# 1 Purpose of Document

This document summarizes the changes between the previous SAP5 silicon revision C and the current silicon revision D. These include requested UART design changes. The purpose of the redesign was to correct reported timing errors by the UART in the following modes: Master, Monitor, and Repeater. A problem with slave communication in special network constellations was also fixed.

**Figure 2.1 Comparison of Valid MAN-Code Signal to Faulty MAN-Code Signal**

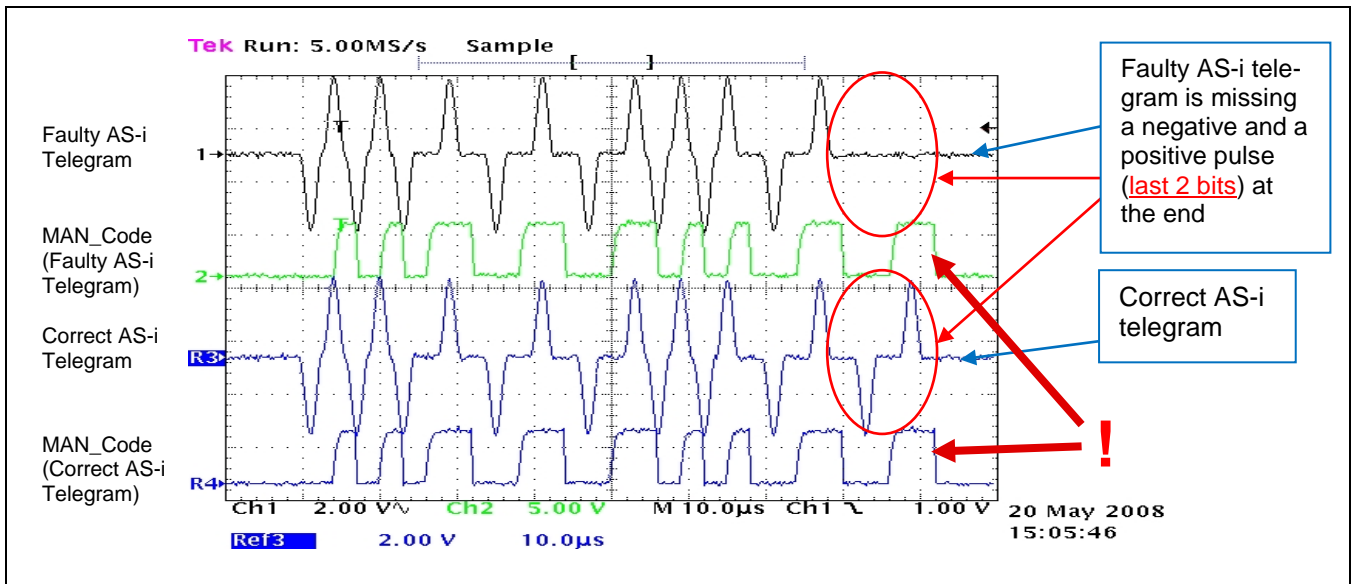
If the SAP5 revision C operates in Master Mode or in Repeater Mode, the error signaling for an *End\_Bit\_Error* does not work correctly. In some special cases, the generated MAN-Code of a signal with an *End\_Bit\_Error* looks similar to the MAN-Code of a signal without any errors as demonstrated in Figure 2.1.

This malfunction of the SAP5 revision C results in an MAN coded output signal that does not allow distinction between correct AS-I pulse sequences and pulse sequences that are shortened (missing one negative and one positive pulse). It occurs only under the following conditions:

- The parity of the signal is even.
- The last bit of the corrupt telegram is equal to binary 1.
- The *Stop\_Bit* and the *Parity\_Bit* or the *Start\_Bit* and the *Control\_Bit* are missing.
- If the *Start\_Bit* and the *Control\_Bit* are missing, the first pulse must have a negative polarity.

The following changes in the UART block were implemented in SAP5 silicon revision D:

1. A new principle for ASI-telegram pause detection was implemented. The previous method caused erroneous pause detection in some cases; e.g., a telegram starting with a wrong Start bit (SB=1) and second bit = 0.
2. A new *Endbit\_error* detection principle was implemented to comply with the *AS-I Complete Specification V3.0*. The new principle ensures that an *Endbit\_error* is detected only if the polarity of the pulse at time (36µs/78µs ± tolerance) is negative.
3. The internal computation of *No\_info\_error*, *Timing\_error*, and *Length\_error* was reviewed and corrected to comply with the *AS-I Complete Specification V3.0*.

**Figure 3.1 Test for SAP5 Revision C Error in Master Pause Detection**

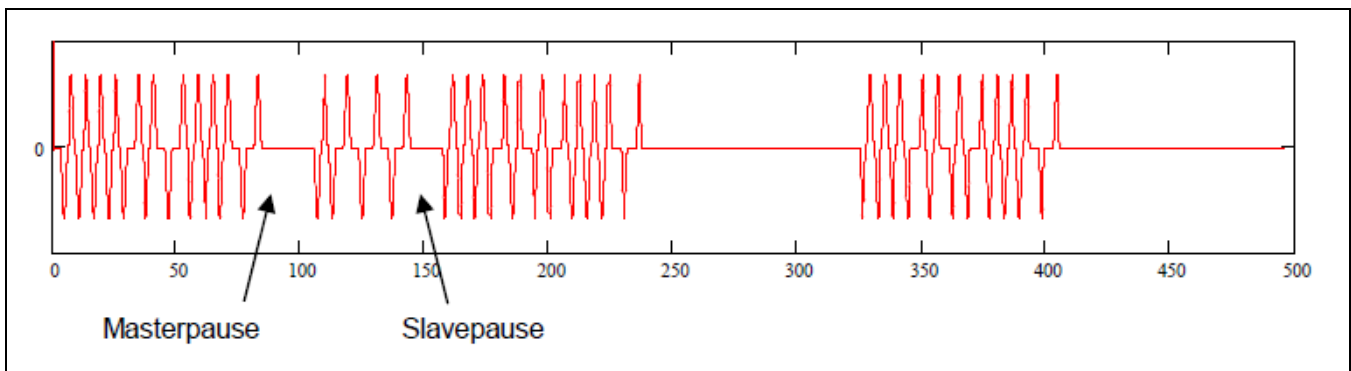
If the previous SAP5 revision C is operated in Slave Mode, the UART Master Pause detection does not always function correctly when the UART must listen to slave responses from a different slave. Depending on the actual AS-I line pulse timing, a slave response from a different slave is sometimes not recognized correctly, which results in a UART communication error. This prevents the Slave from understanding the next Master telegram correctly. If the Master telegram addresses the Slave itself, the error leads to a missing slave response and the Slave replies on a second repetition of the Master Call to its own address in asynchronous mode.

Figure 3.1 shows a telegram test case to reproduce the error. The AS-I signals shown in Figure 3.1 were generated by a signal generator that allowed sweeping the Master Pause and Slave Pause duration over the allowed specification limit. The first Master Call contains a different slave address than the tested slave. The second and third master calls address the tested slave. The tested slave replied with the erroneous behavior for certain Master pause and Slave pause scenarios only. The majority of the test cases were passed without error.

A new principle of AS-i telegram pause detection was implemented in SAP5 silicon revision D that is more precise and able to cover all valid timing scenarios for Master and Slave pauses. The new principle is now independent of the internal timing constraints of the UART state machine.
